1. Please note that the 731 states that the PC is for part 24, part 15C and part 25B. However, only a test report for part 24 has been provided. IF the changes are for part 15C and 15B, please provide the necessary test reports for those rule parts. If the PC is only for part 24 please justify no change to part 15C and 15B.

Figure 1 – Ungrounded Pad

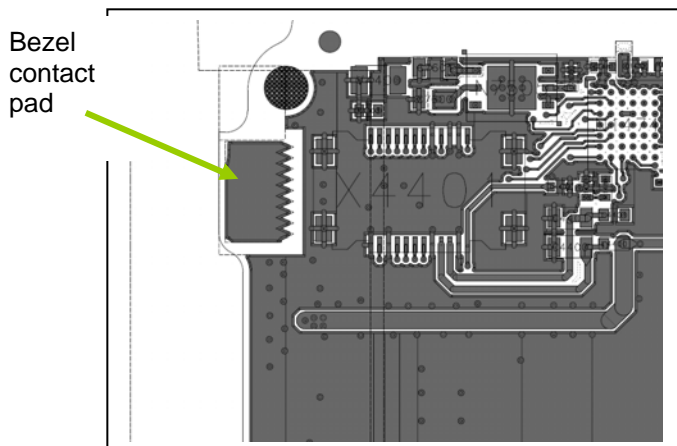
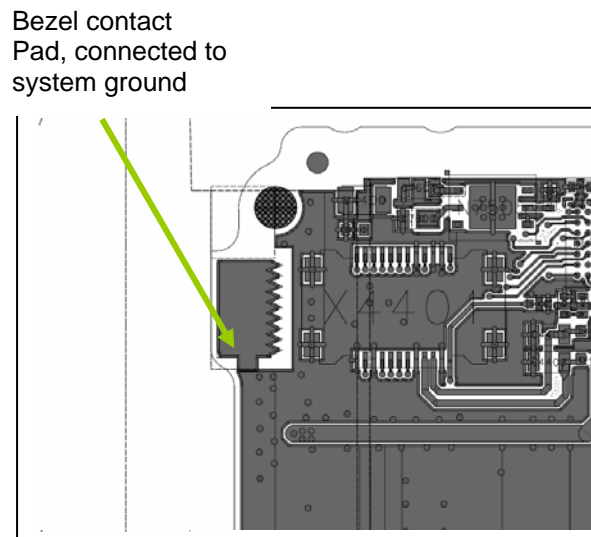
3. Please provide internal photos showing the changes if possible.

Prior to change, the A-cover bezel was not grounded. Satisfactory ESD performance was achieved by connecting the bezel through a spring on the A-cover, to a clip on the UI frame and then to the Bezel contact pad on the main pwb as shown in Figure 1. A spark gap was implemented on the pwb as shown in Figure 1 below

With the new PWB this spark gap has been shorted as shown in Figure 2. This is a copper only change; no component values have been changed.

Figure 3: Old vibra pad layout

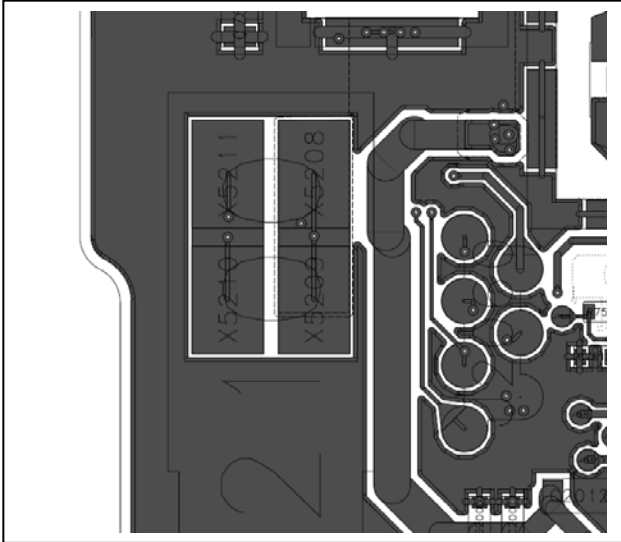
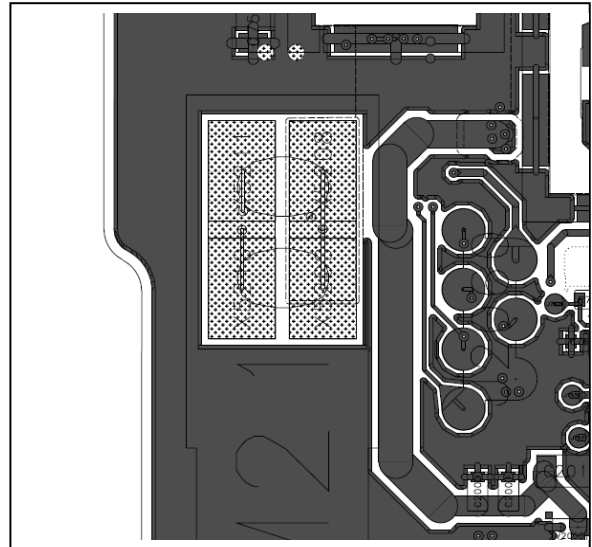
The clearance round the vibra pads has been increased as shown in Figures 3 and 4 below

The two vibra decoupling capacitors have decreased in value to compensate for the change in capacitance between the vibra pads and ground.

Figure 9 - Layer before changes

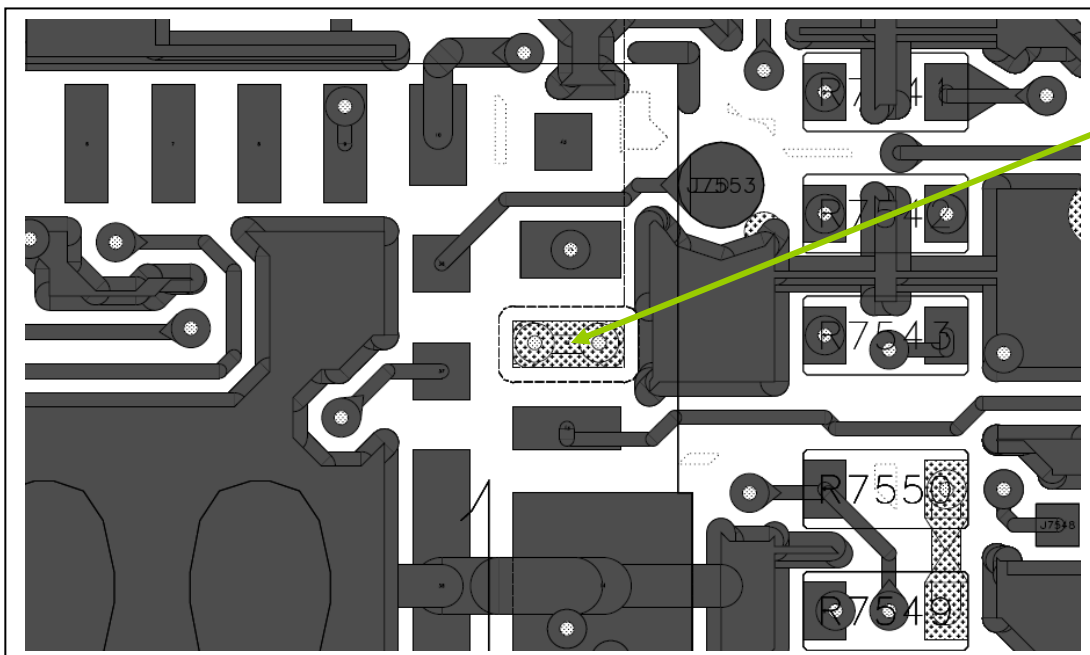
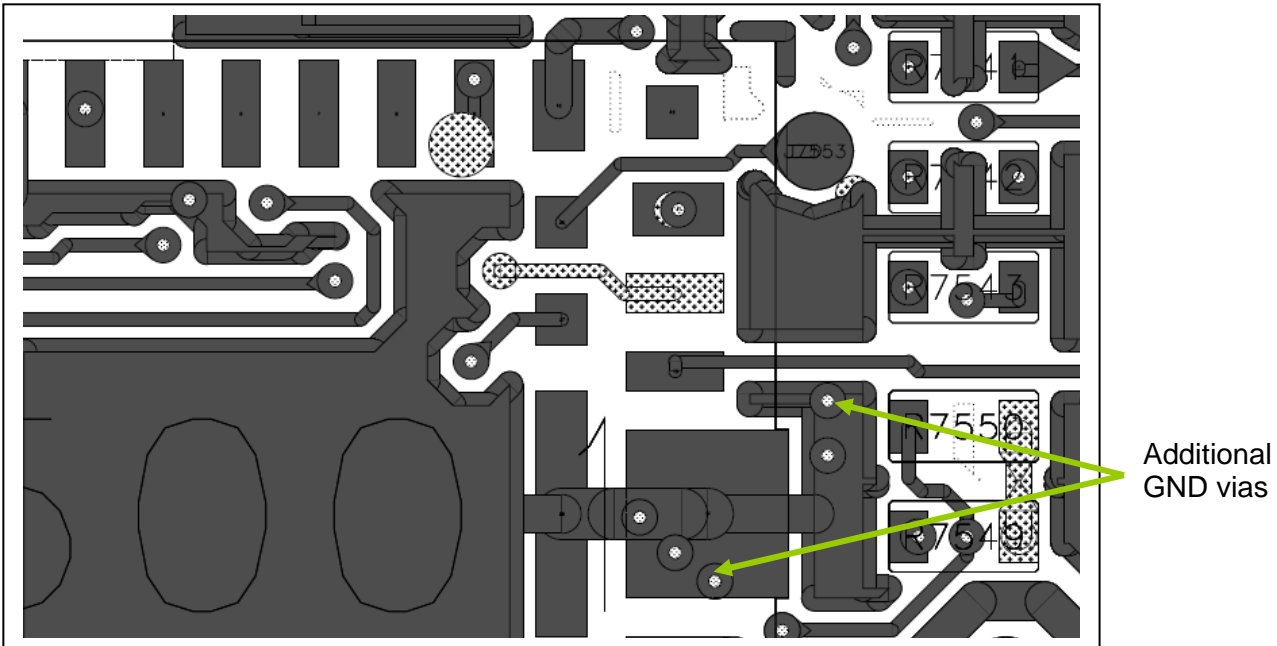
Copper change to improve the grounding and shielding under the FM Antenna.

- 1) Remove Vias from Pin 12 of D5001 and track and under the device.
- 2) Additional GND vias from layer 8 to layer 6 to improve ground stitching.
- 3) Increase the GND areafill on layer 7 under pin 13 to improve shielding from signal tracks on layer 6.
